Lease & Well # 3001520792

Randall Federal #1

COG Operating NM-7752: Randall #1 API: 30-015-20792 Eddy County, New Mexico

RE: Plugging and Abandonment Requirements, Conditions of Approval

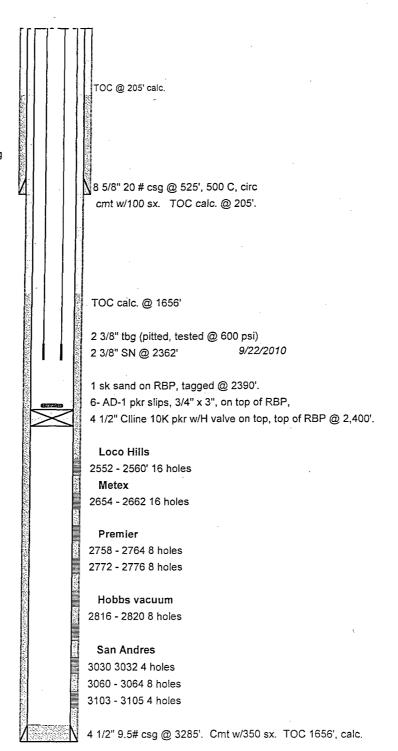
- 1. BLM shows no record of a CIBP being set. Tag PBTD, and if between 2504'-2402', set CIBP at PBTD with 25sx on top Otherwise OK (Perfs)
- 2. OK
- 3. Change: Perf and squeeze a plug (minimum 25sx) from 1250'-1140'. Tag at 1140' or shallower. If injection rate cannot be established, spot cement 50' below perfs. (Yates BOS)
- 4. Tag at 465' or shallower Otherwise OK (TOS Casing shoe)
- 5. OK (Surface)
- 6. Verify that all annuluses have cement to surface and fill in as required. Ground Level Dry Hole Marker shall be used in this area Requirements attached.
- 7. Submit a subsequent report to the BLM.
